SERVICE BULLETIN
REVISION TRANSMITTAL SHEET

EQUIPMENT/FURNISHINGS - Lavatories - Seal Openings in Lavatory Washstand.

This page transmits Revision 1 for DC-9 Service Bulletin 25-264 to incorporate the following changes:

Bulletin 25-264

FORWARD AND/OR AFT LAVATORY WASHSTAND - MODIFICATION

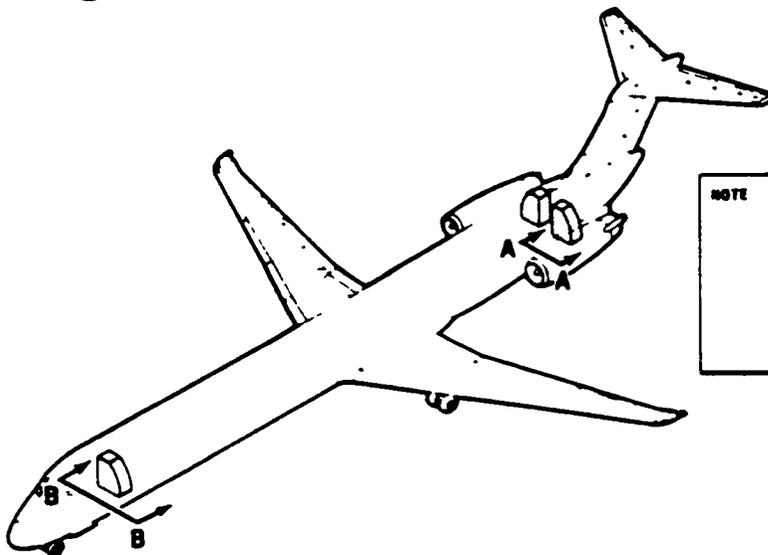
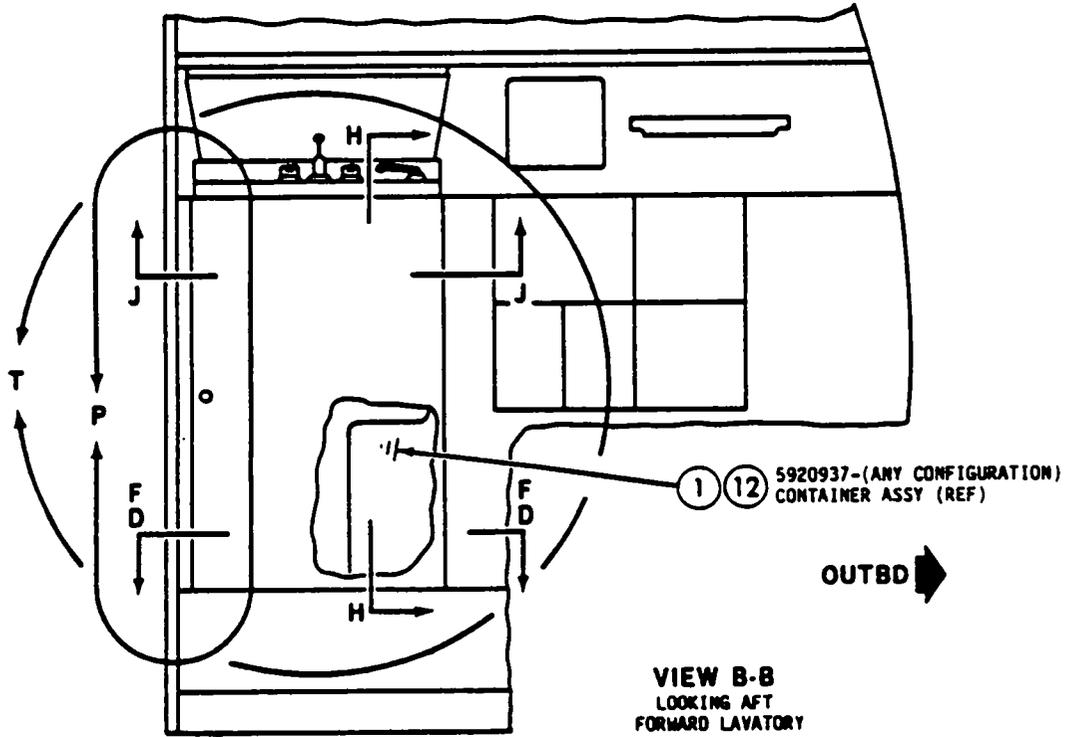
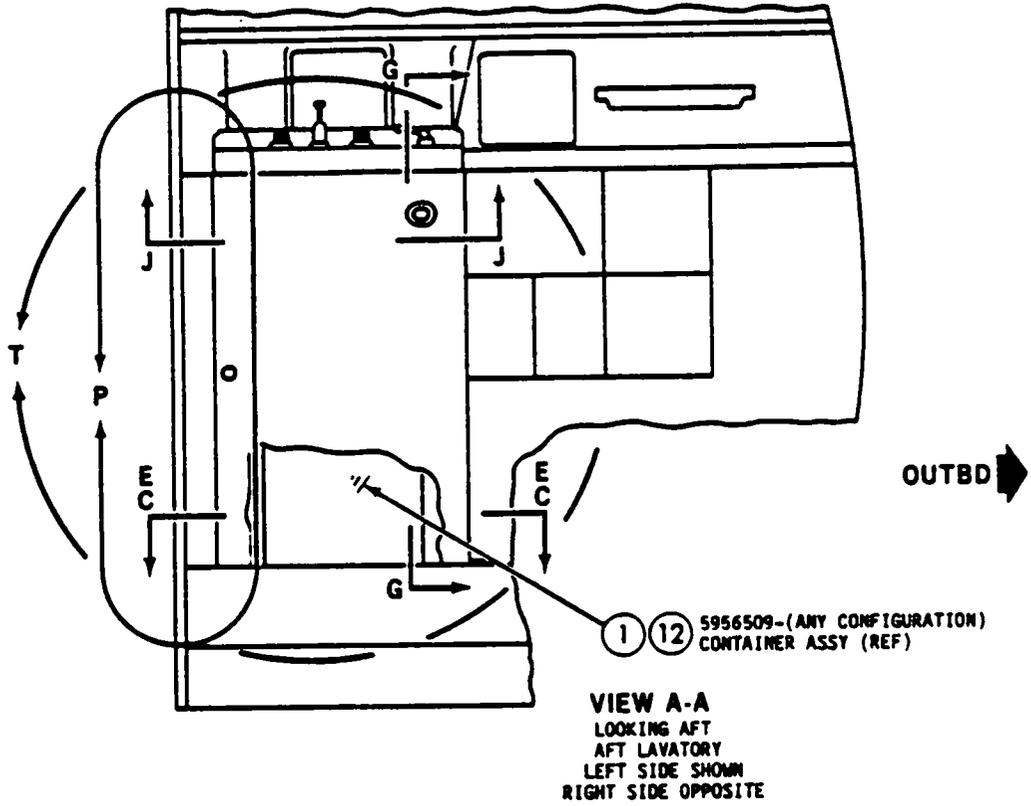
Install seal per instructions outlined on Figure 1, work step 6.
An additional 0.5 man-hour is required per seal.

- Pages 1 thru 8: Changed page number to 1 of 22, was 1 of 21.
Deleted operator codes FL, IW, NY, OC, OD, UA, XAS, ZKD, ZS8, ZWH, ZWX, ZYO, Z4F, and 2C.
Added operator codes FP, NW, XYX, YUZ, ZDF, ZER, ZIB, and ZK8.
Revised Effectivity to reflect current operators of affected aircraft.
- Page 9: Revised production statement.
- Page 10: Changed Manpower requirements.
- Page 13: Revised instructions to install two SR09250001-9 seals in work step 6.
Added work step 7A.

- ⑥ INSTALL TWO SR09250001-9 SEALS.

- ⑦ APPLY A BEAD OF 732 RTV SILICONE SEALANT.
- ⑦A INSTALL THREE NAS1836-06-08 INSERTS IN FILLER. (SEE MAINTENANCE MANUAL CHAPTER 20-19-0, PARAGRAPH ENTITLED, "SINGLE STEP INSTALLATION OF BLIND INSERTS WITH POTTING HOLES.")
- ⑧ APPLY EC2216 B/A ADHESIVE TO SR09250001-7 FILLER AND INSTALL ON DOOR JAMB.
- ⑨ INSTALL SR09250001-3 AND -4 ANGLE ON FILLER.
- ⑩ APPLY TWO COATS OF TIP-6041 MOLD RELEASE TO DOOR JAMB AND ANGLES. (ALLOW 15 MINUTES DRYING TIME AFTER EACH COAT.)
- ⑪ MASK AREA TO BE SEALED TO ENSURE STRAIGHT EDGES AND APPLY SEAL AROUND PERIPHERY OF DOOR USING 90-006 SEALANT WITH 90-006-2 CATALYST. ALLOW SEALANT TO CURE FOR 24 HOURS WITH THE DOORS IN THE CLOSED AND LATCHED POSITION. REMOVE TAPE AND EXCESS SEALANT.
- ⑫ REINSTALL RETAINED 5920937 AND/OR 5956509-(ANY CONFIGURATION) CONTAINER ASSEMBLY.

FIGURE 1 (SHEET 7 OF 8)

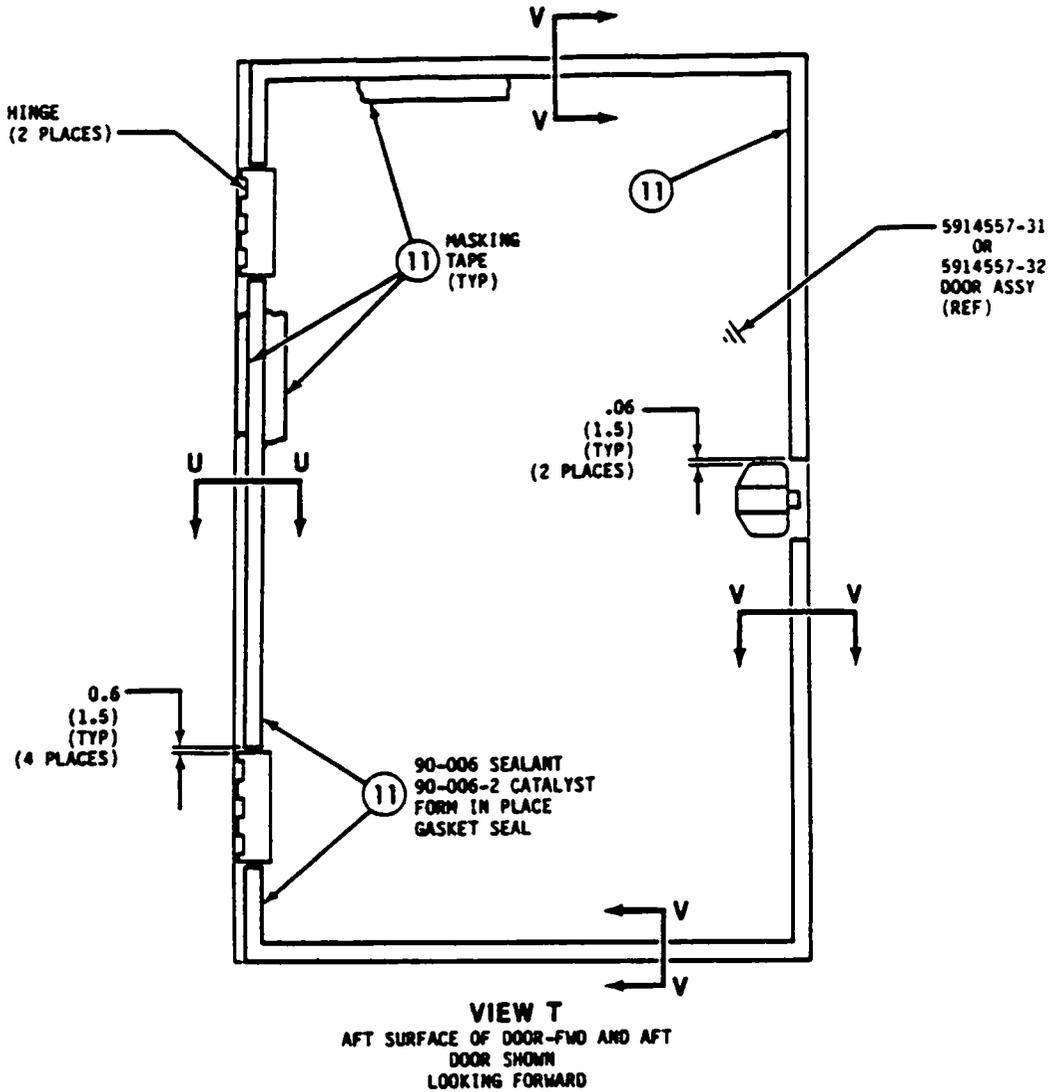
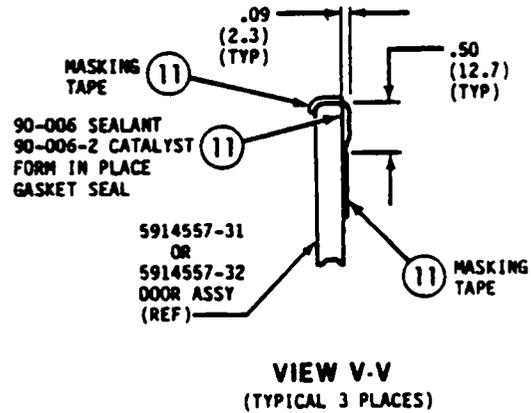
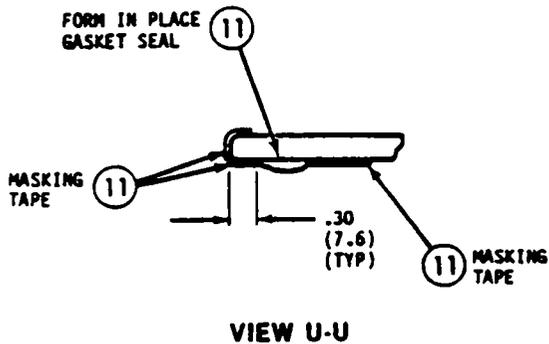
Page 18: Added Section W-W callout to views R-R and S-S.

FIGURE 1 (SHEET 8 OF 8)

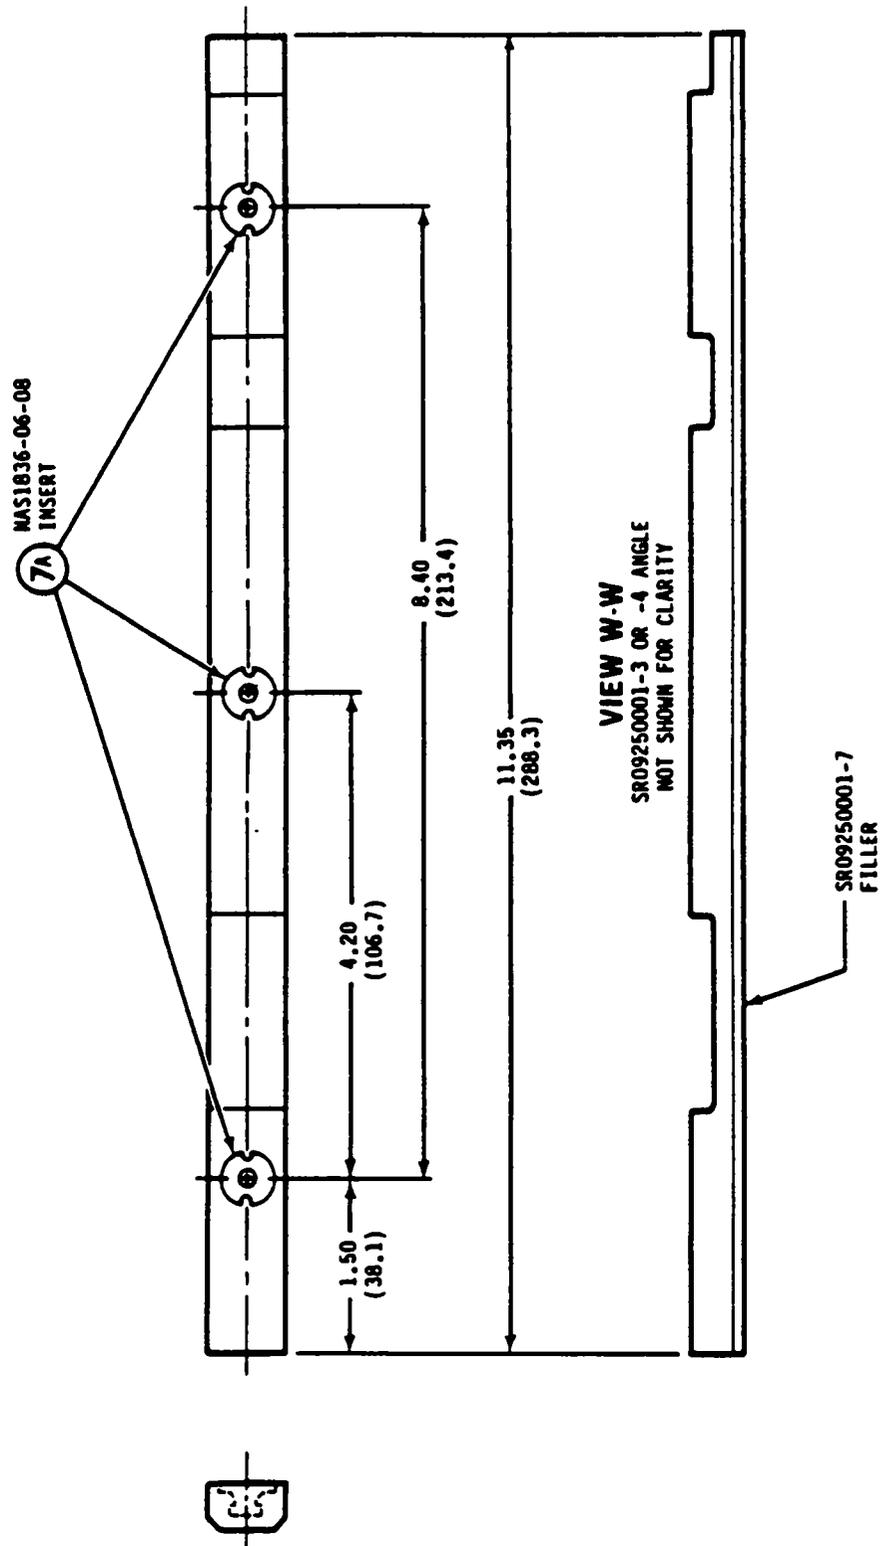
Page 20: Added VIEW W-W.
